Access Compliance Report Public Rights-of-Way (Curb Ramps)

Main Street: CHIQUITA_CANYON_DR Cross Street: CHIQUITA_CANYON_DR Location: SW

ADA ID: RPRK211124132735 Ramp Type: Type 1 - Perpendicular Diagonal Initial Pass/Fail: Pass Overall Compliance: No Severity Score: 9

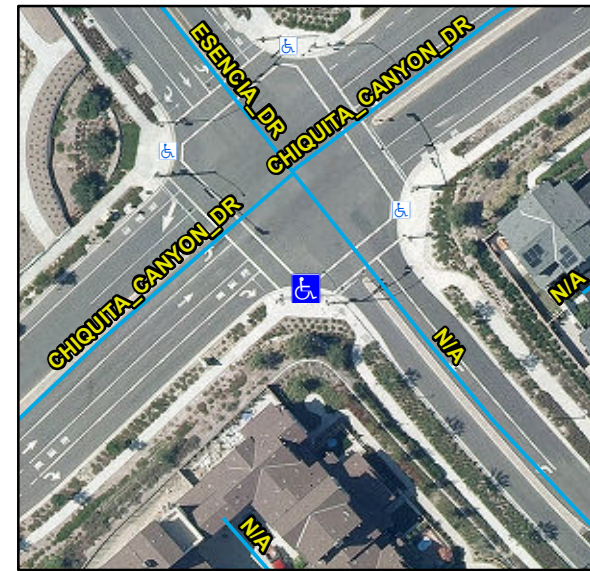
R304.2.2, R304.2.1, R304.5.4, STD 1115

Remove & Replace Curb Ramp With Two New Directional Ramps or Equivalent. Remove & Replace Gutter.
